**BOARD OF ZONING ADJUSTMENT  
STAFF REPORT**

5685

Advanced Disposal Services Gulf Coast, LLC (Joe Stevens, Agent)

**PARKING SURFACE:** Parking Surface Variance to allow a gravel parking and maneuvering area for a disposal and recycling facility in a B-5, Office-Distribution District.

# SITE PLAN

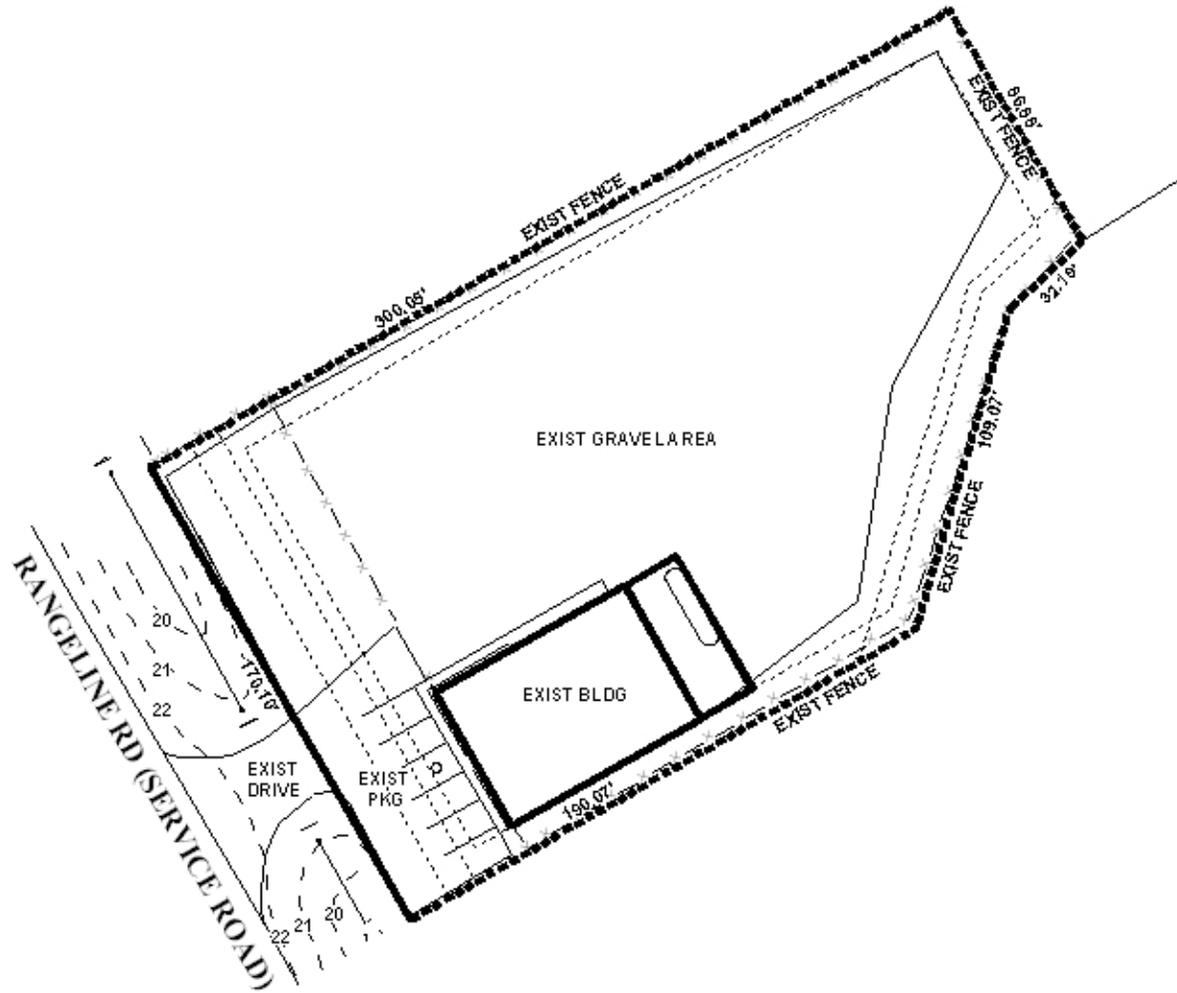
The aisle (the area behind the back of the parking stalls) appears to be less than 24'. The driveway radii should be at least 24'. ALDOT should also be notified. The southern most parking stall needs a slip to allow the motorist room to back out and exit the parking lot headlights first. For head in (90 degree) parking: parking stall dimensions shall be a minimum of 9 feet wide and 18 feet deep. The aisles shall be at least 24 feet wide. If you will be working in the roadway or performing any activities that will affect traffic, you must submit a Traffic Control Plan at least two working days prior to proceeding.
